SCHWEIZER SERVICE BULLETIN

C1B-026
26 Sep 2008

SUBJECT: LANDING GEAR SKID TUBE AFT SLEEVE INSPECTION

Figure C1B-026-1. Aft Sleeve

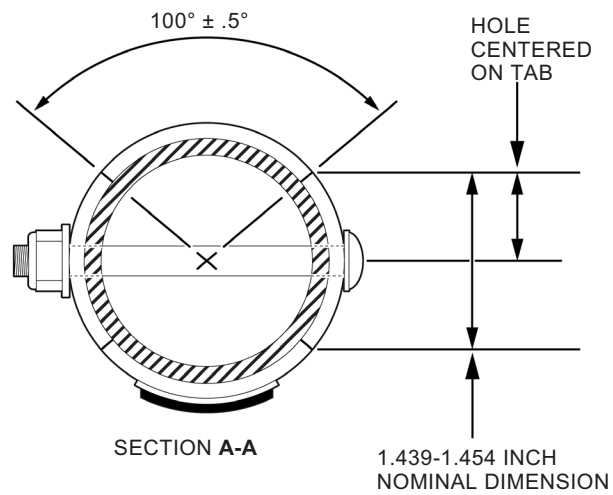
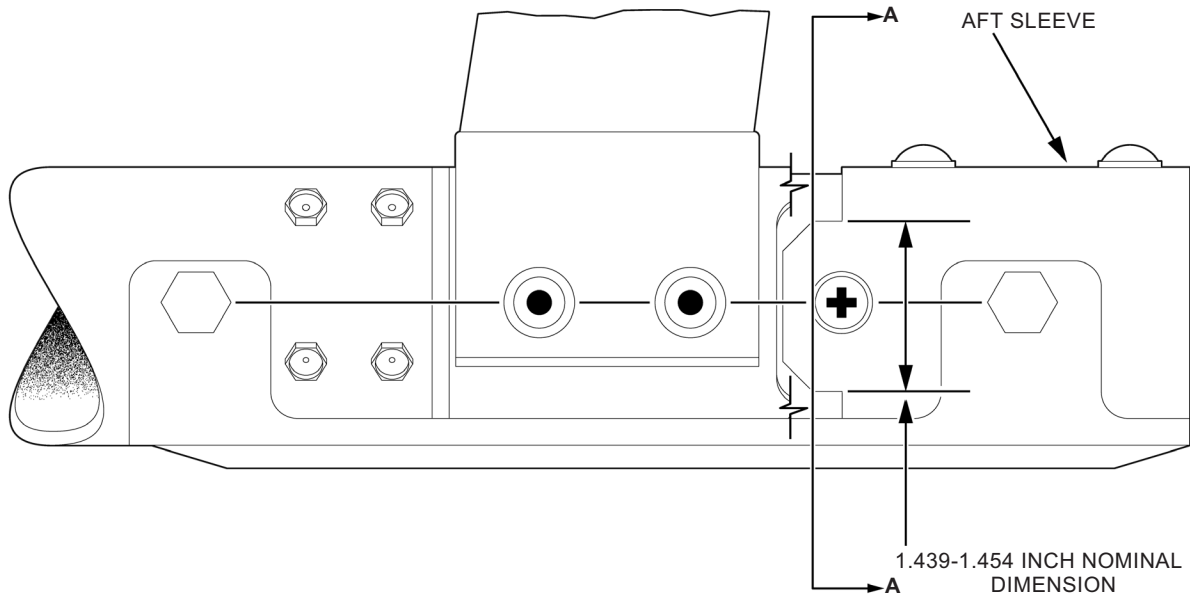
- It has come to our attention that the tabs of some aft sleeves have been machined incorrectly and this causes a restriction in the rotational travel of the associated component. A dimensional check of the aft sleeve will expose any restriction in the rotational travel.

- Install ground handling wheels and raise aft skid sleeve extension from ground.
- Using a caliper, measure both tabs of aft sleeves as shown in Figure C1B-026-1. Dimension of aft sleeve tabs should be between 1.439 to 1.454 inches.
- If either tab dimension is over 1.454 inches, replace aft sleeve with serviceable sleeve in accordance with Basic HMI Section 12 within next 100 hours of flight time or 3 months whichever comes first.
- Measure all spare aft sleeves in stock purchased between December 2007 and July 2008 for tab dimension of 1.439 to 1.454 inches. Remove from stock all sleeves that do not pass inspection.
- Record compliance with this Service Bulletin in the aircraft records.
